Subject: NEI Comments on Draft NRC Vision and Strategy: Safely Achieving Effective and Efficient Non-Light Water Reactor Mission Readiness (Docket ID: NRC-2016-0146)

Project Number: 689

**NEI Comments on NRC's Draft Vision and Strategy: Safely
Achieving Effective and Efficient Non-Light Water Reactor Mission Readiness**

Non-LWR Deployment Timeline with Part 50 Construction Permit and Operating License*

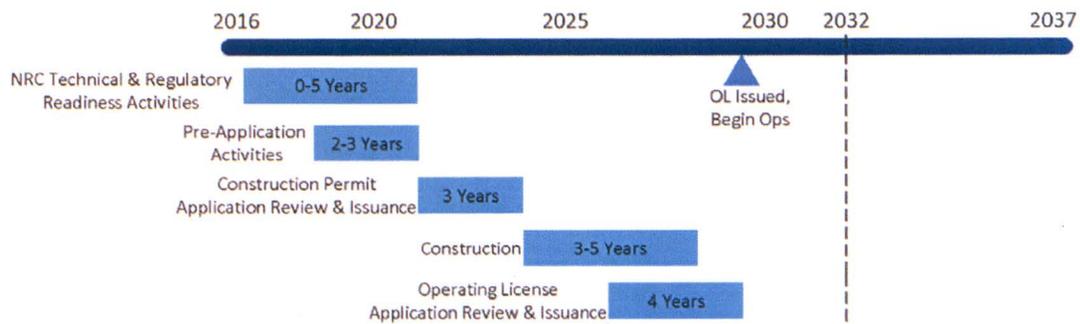
We appreciate that the NRC has provided timelines for deployment of non-LWRs under two licensing scenarios, but we believe that the timelines do not appropriately depict the staff's readiness to conduct effective and efficient non-LWR reviews. Specifically, the timelines show receipt and review of a non-LWR application after nine years of readiness activities. Because establishment of a non-LWR review process is a key strategic goal of NRC readiness activities over the 0-5 year time frame, we believe the timelines should reflect this. Showing readiness to review non-LWR applications after the 0-5 year period would be consistent with the Vision and Strategy which indicates that NRC activities after the 0-5 year period will shift to a focus on rulemaking. We and the staff have agreed that rulemaking would be pursued at an appropriate time, as needed, and is not necessary for review of initial non-LWR applications.

The NRC added a note on the timelines to explain the nine years of readiness activities stating, "The estimated activity durations shown above reflect the longest timeframes allowable in order for the NRC to achieve alignment with DOE's goal of non-LWR deployment (construction) in the early 2030s." Rather than attempt to mitigate via notation the strong visual effect of the timeline, the timeline should be modified to better reflect plans and expectations regarding readiness for efficient, effective regulatory review of non LWRs. It is unnecessary to depict the "longest timeframes allowable" for meeting the DOE goals. Moreover, rather than present timelines based on DOE goals, the NRC timelines should focus on NRC readiness and the

expectation that an efficient and effective regulatory process can be in place after five years. The NRC could choose to include a note on the timelines or in the text stating that the NRC timelines provide ample margin to meet the DOE goal of non-LWR deployment (construction) in the early 2030s.

In addition, the timelines should reflect that pre-application activities could begin within the 0-5 year period. In this regard, we note that the scope of DOE's advanced reactor Funding Opportunity Announcement awards include interactions with NRC. These interactions are expected to include submittal of white papers, within the next few years, addressing topics that would have an overarching impact on the safety case and overall advancement of the design. Attached are proposed alternate timelines that reflect this shorter regulatory readiness timeframe as well as modified review timeframes (further discussion on review timeframes is provided in other comments). Because of the importance of the timelines as a communication tool, we believe it is important that they appropriately reflect plans and expectations regarding readiness for efficient, effective regulatory review of non LWRs.

2. The notional schedules presented in the Vision and Strategy document show non-LWR review periods of 4-5 years. These time frames are not consistent with the expected safety focus and efficiency benefits of the more effective and efficient review process that is a key objective over the next five years. In addition, it is expected that review time can be shorter for advanced non-LWR reactors that, consistent with the Commission's 2008 Policy Statement on the Regulation of Advanced Reactors, "provide enhanced margins of safety and/or use simplified, inherent, passive, or other innovative means to accomplish their safety and security functions." We note that the NRC has established a 39 month review schedule for design certification application for a (LWR) Small Modular Reactor.

As shown in the alternative timelines attached, we recommend the use of ranges to account for the potential that periods for pre-application interactions, design review, and construction may be shorter than assumed in the NRC timelines.
